**RE: 7 – 11 SARGENT STREET, NEW FARM
RESPONSE TO COUNCIL INFORMATION REQUESTS**

This letter has been prepared by PTT, as requested by Bolton Clarke, in response to traffic engineering related items raised in an information request issued by Brisbane City Council (Council), received via email dated 14 May 2026. The development application (Council Reference: A006989439) seeks approval for a Minor Change to an approved retirement facility over the subject site.

Figure 1: SSD AT SITE ACCESS

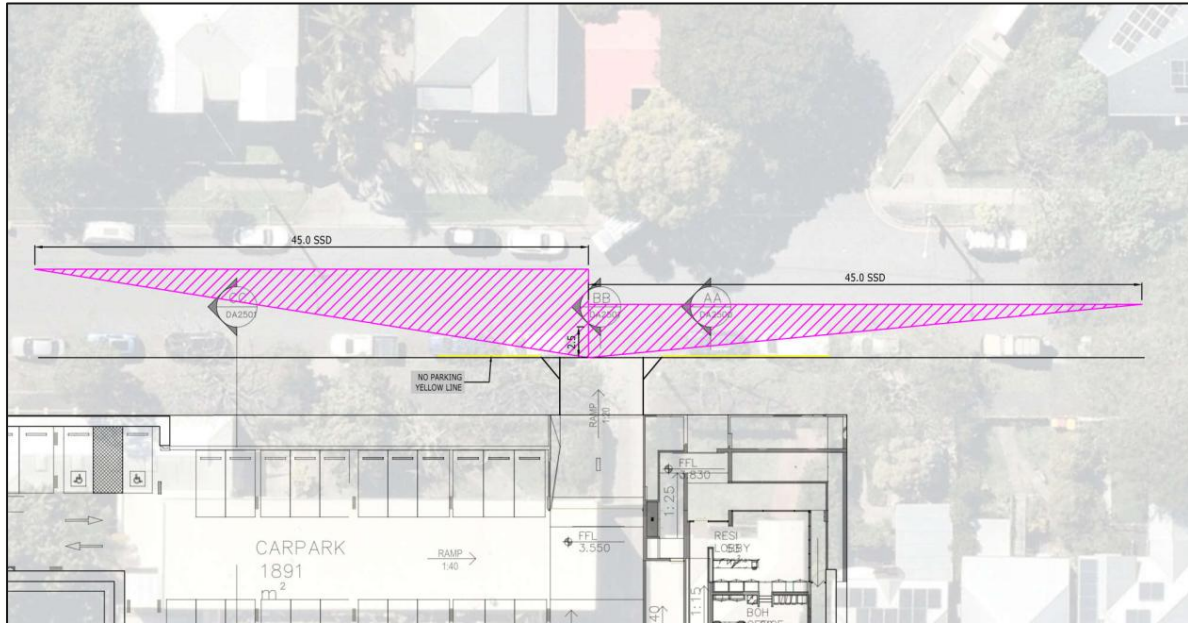
While it may be lawful for a car to park immediately adjacent to the access crossover tapers, it is our view that cars parked at these locations would reduce the available sight distance at the access. For an access driveway carrying less than 100 vehicles per hour and located in a 50km/h speed environment, Table 7 in Council’s Transport, Access, Parking and Servicing (TAPS) Policy requires an absolute minimum sight distance of 70m. By comparison, Australian Standards AS2890.1 Parking Facilities Part 1: Off-Street Car Parking requires an absolute minimum sight distance of 45m. Given the low speed urban environment on Sargent Street and the high demand for on-street parking, we have adopted the AS2890.1 minimum requirement.

Note 3 to Figure 3.2 in Section 3.2.4 of AS2890.1 states that parking on the frontage road ‘may need to be restricted on either side of the driveway so that sight distance required by the above table to an approaching vehicle is not obstructed.’ Thus, in order to achieve the absolute minimum sight distance (ie 45m) required by AS2890.1, on-street parking restrictions are required on both sides of the access

driveway, as shown in Figure 1. It is therefore recommended that no parking yellow lines be installed at these locations to restrict on-street parking.

DRAWING TITLE: **BCC RCV MANOEUVRING**

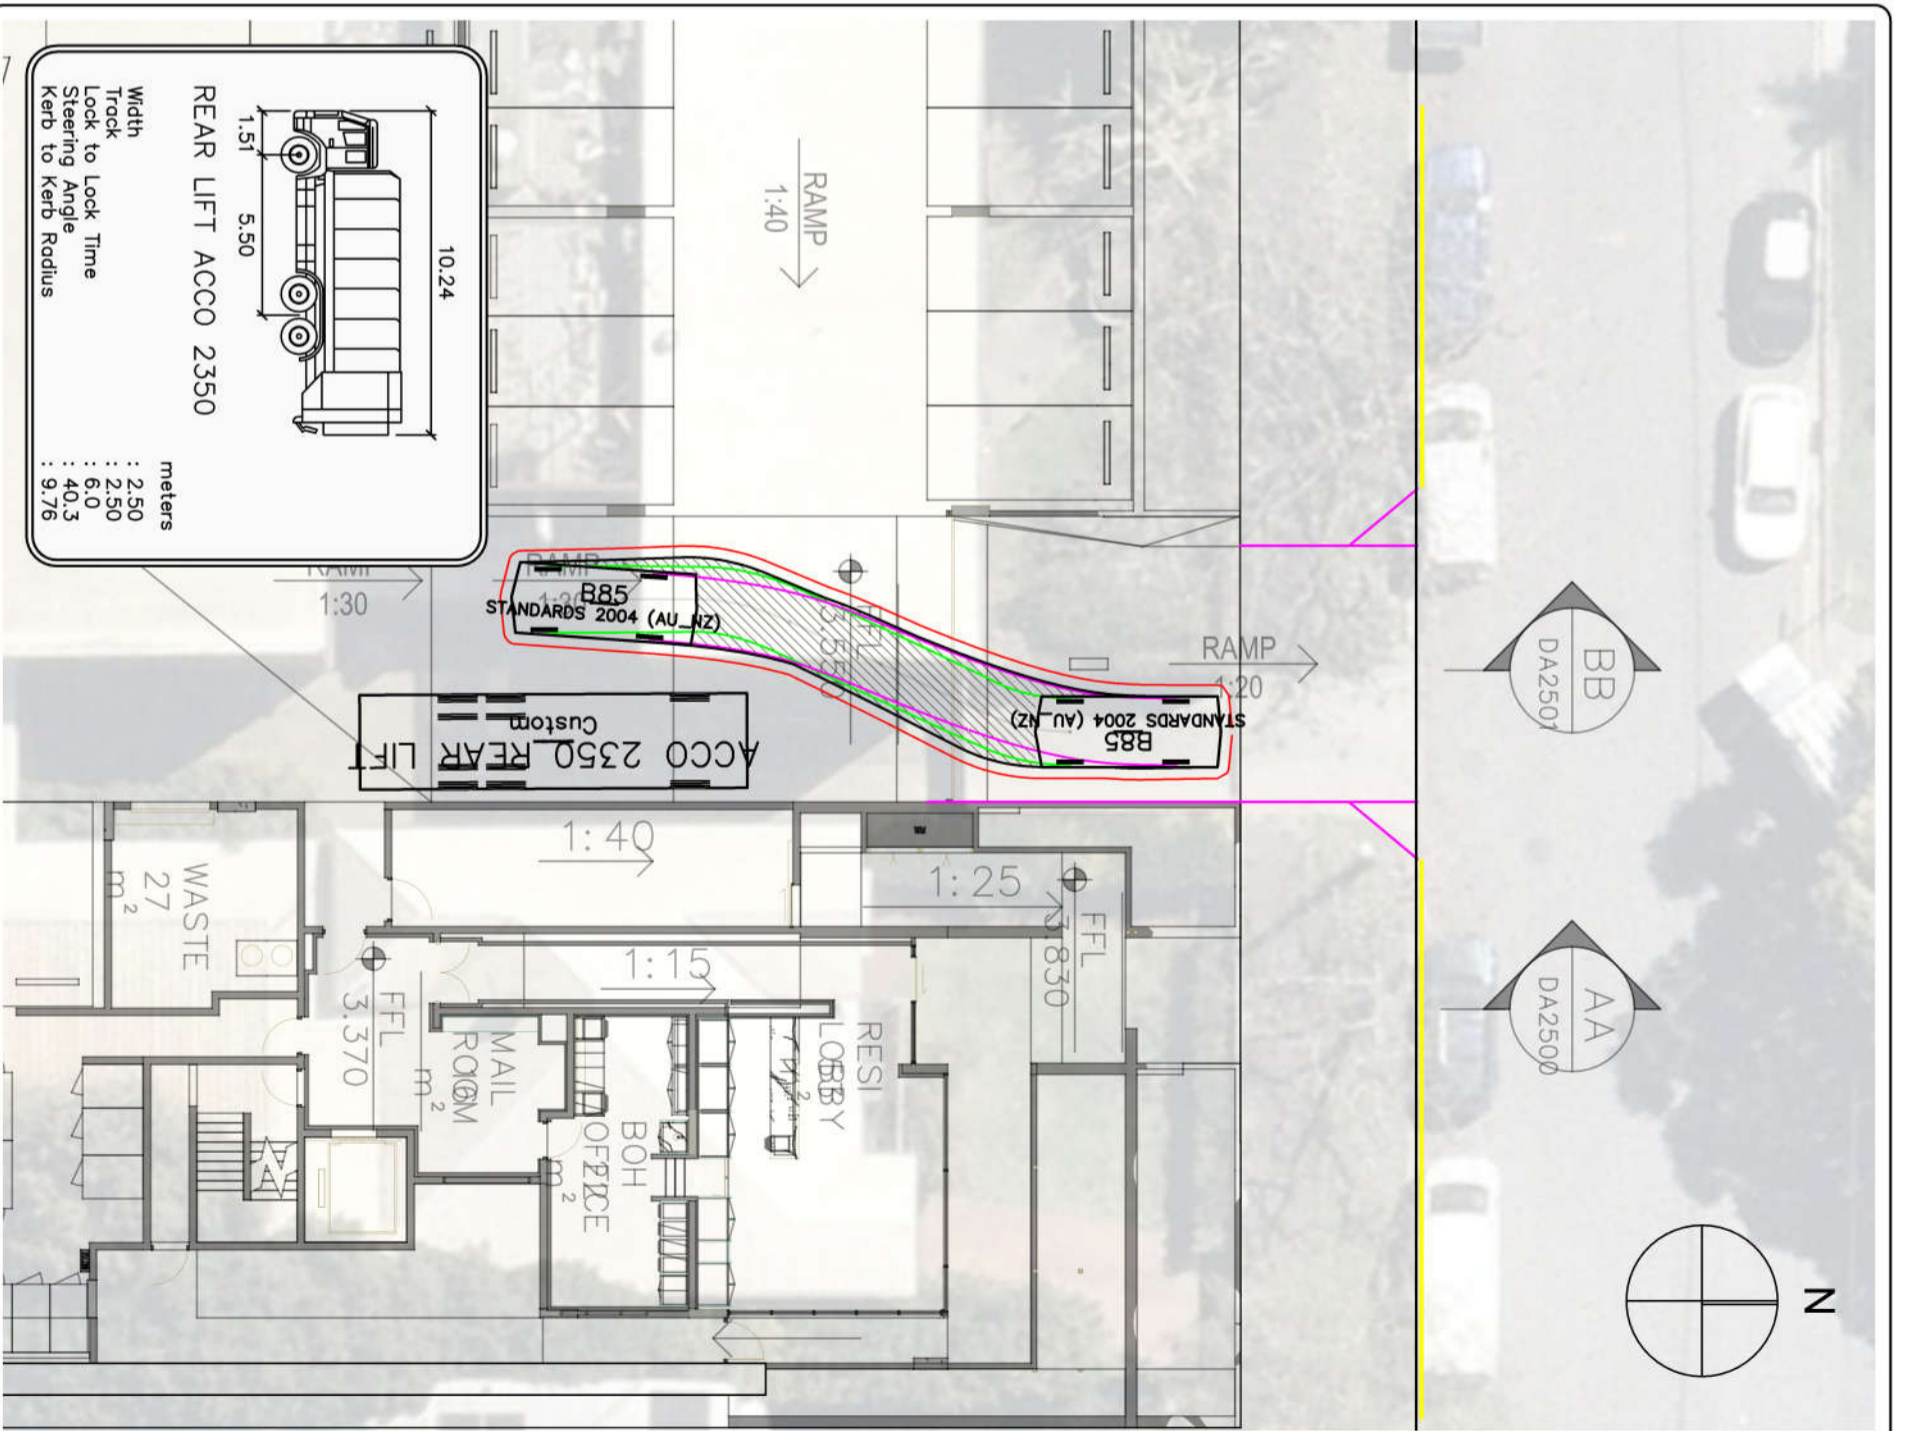
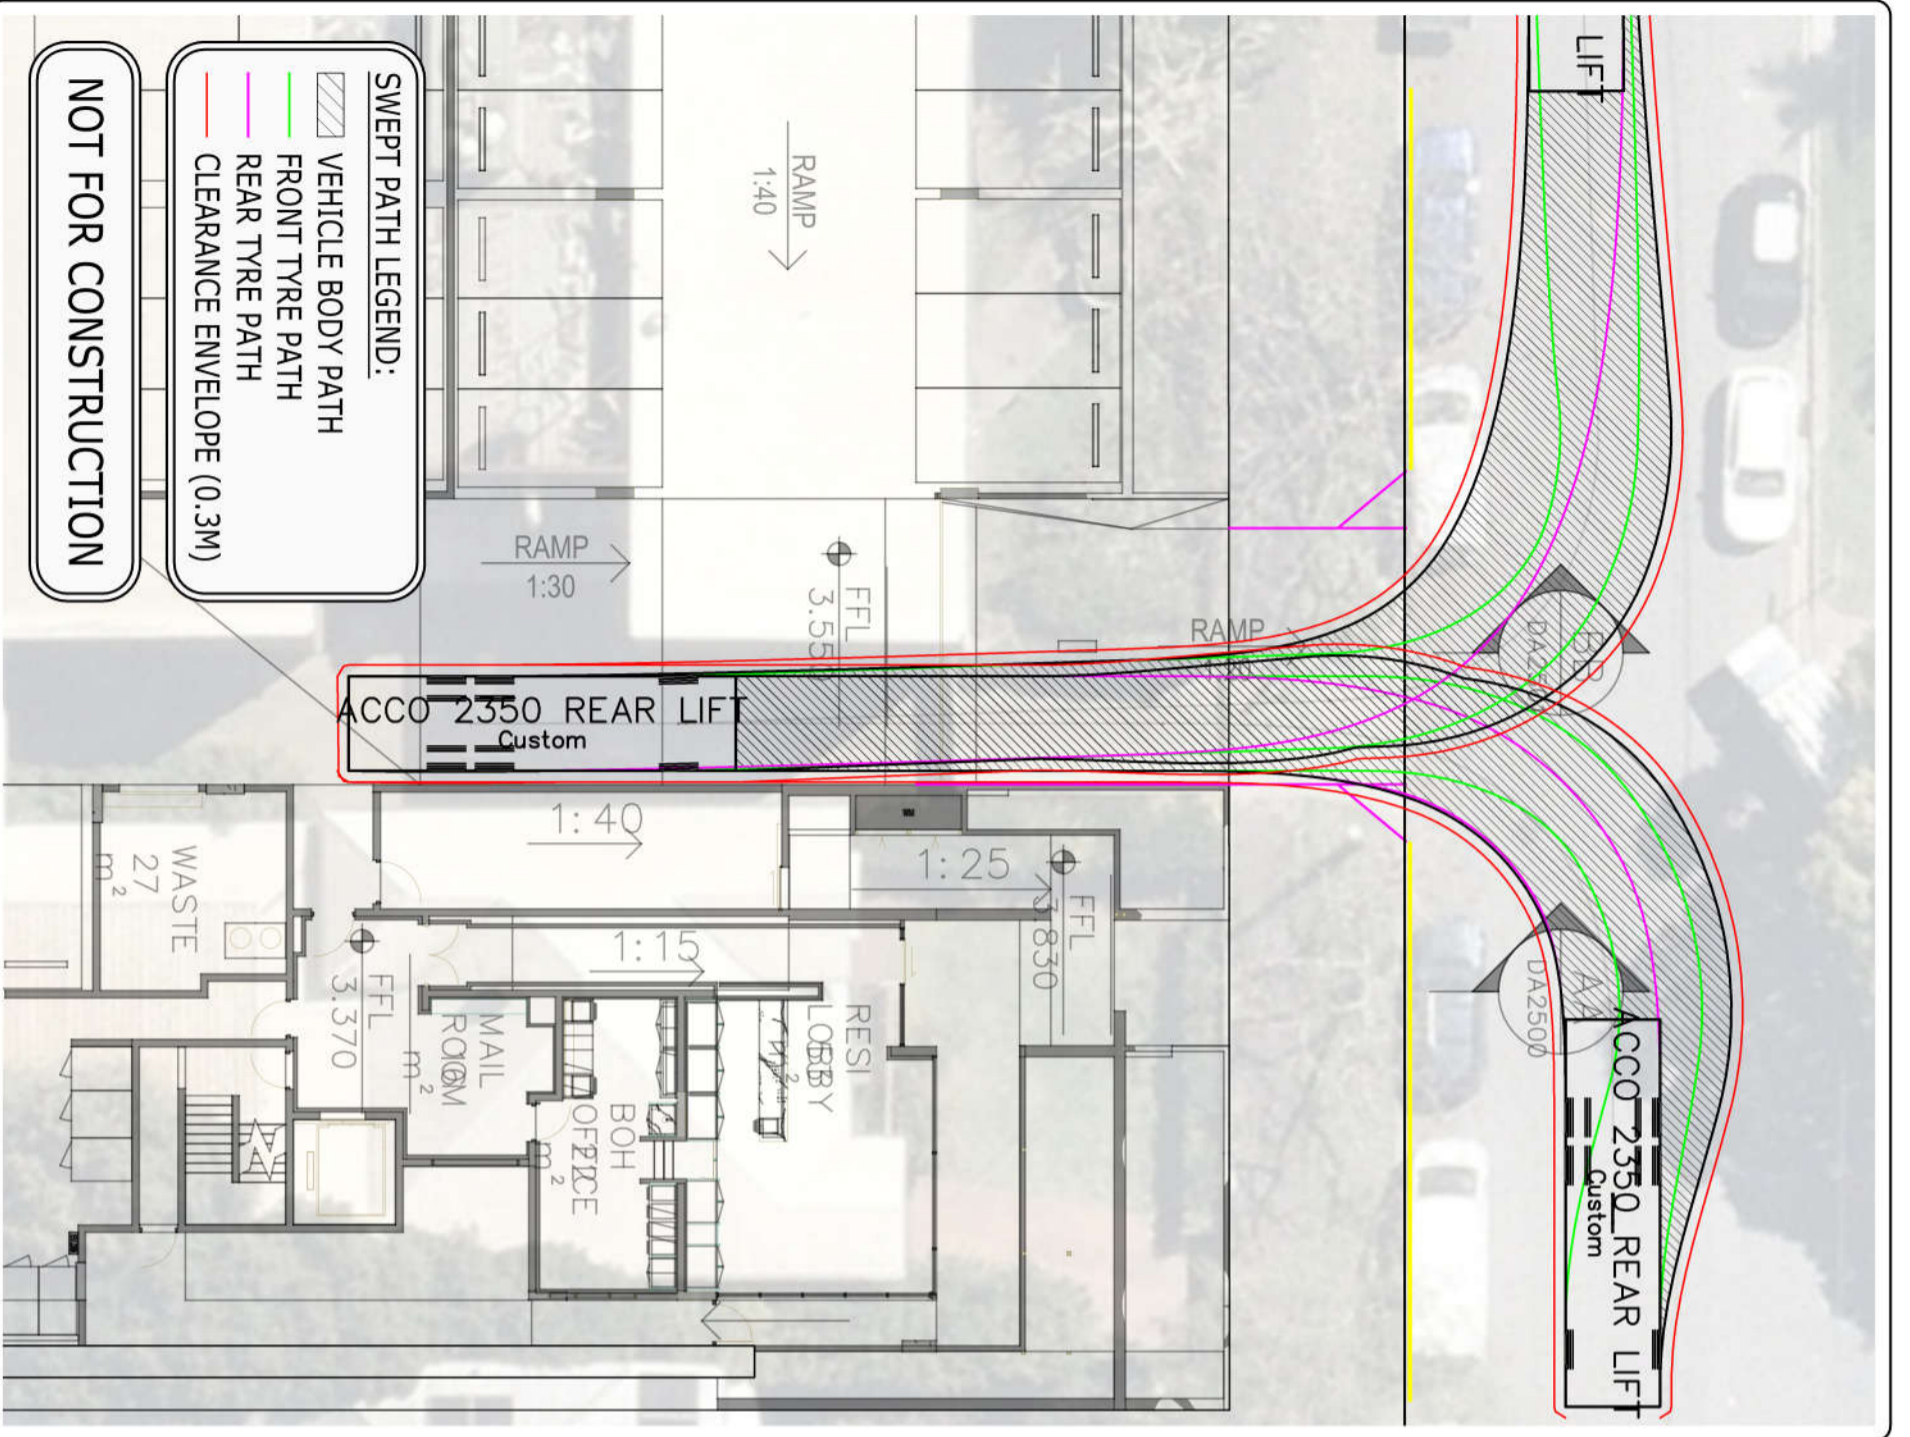
- updated refuse collection vehicle (RCV) swept paths demonstrating that the truck can egress the site while cars are parked adjacent to the exit kerb taper of the crossover, with Council noting that cars can lawfully park immediately adjacent to the taper
- updated RCV swept paths which demonstrate a kerb-to-kerb radius of 9.76m as per Council Standard Drawing BSD-3009

A swept path of a Council rear-lift RCV accessing and egressing the site access is attached. Given the recommended parking restrictions outlined in Figure 1, vehicles parked on Sargent Street would not impact RCV egress movements. The swept path analyses adopts the minimum kerb to kerb radius (ie 9.76m) prescribed in Council Standard Drawing BSD-3009.

No additional changes to the site access are considered necessary to cater for an RCV.
